November 9, 2023

Re: Young Life (PWS ID#01246)

Membrane Module Replacement with 8 Toray HFUG-2020AN Modules Final Approval – PR# 75-2021

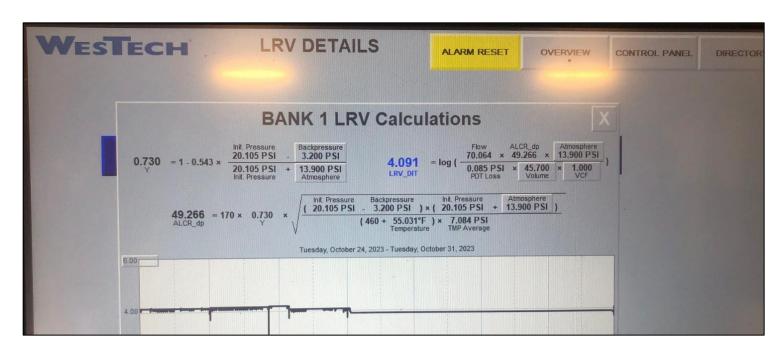
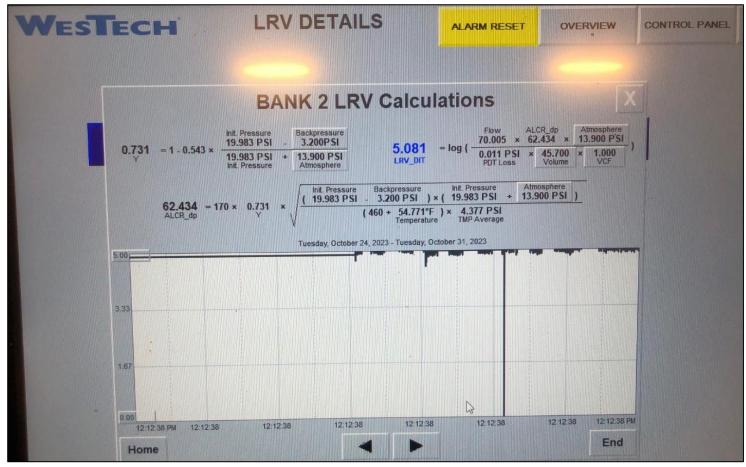
Note: Calculations done for the Conditional Approval letter used an atmospheric pressure (P_{atm}) of 14.7 psi (pressure at sea level), however, the 13.9 psi (1,550-ft above sea level)

that is currently programmed into the PLC is more appropriate for the location of the plant. The difference in LRV using a net expansion factor (Y) of 0.74 versus 0.73 is negligible. As previously mentioned, the backpressure needs to be verified (is it 3.62 psi or is it 3.2 psi?)

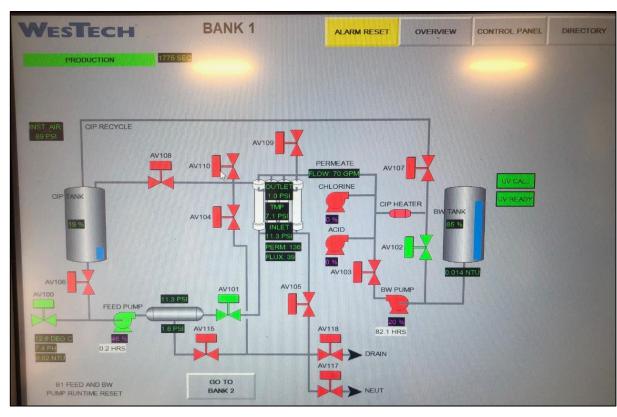
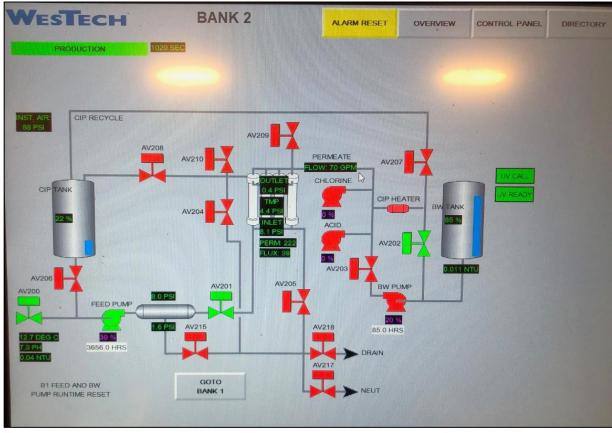
It is noted that on the alarm setpoints SCADA screen, on the lower right, there is a box that says "PDT PSI LOSS 0.090 **PSI**". That is actually the 0.090 **psi/min** loss rate setpoint, and you have verified that this triggers an alarm correctly and is just mislabeled. It is on scheduled

for correction in the spring. Also note that <u>the 0.09 psi/min decay</u> rate set point should be changed to 0.08 psi/min as 0.09 psi/min is based on a <u>sustained</u> starting test pressure of 20 psi as shown in the calculations in Appendix B of this letter. Additionally, the LRV_{ambient} calculation programmed into SCADA uses a maximum backpressure (BP_{max}) of 3.2 psi (88.7 inches of water). The original calculations showed a BP_{max} of 3.62 psi (100.3 inches of water). Please let me know what the verified value for BP_{max} should be

Please let me know what the verified value for BP_{max} should be and make corrections to the PLC programming accordingly.

Also <u>consider setting the permeate turbidity high-high alarm to</u> <u>0.15 NTU</u> rather than 0.90 NTU <u>and the high alarm to 0.05 NTU</u> rather than 5.00 NTU as regulatory and optimal set points, respectively.
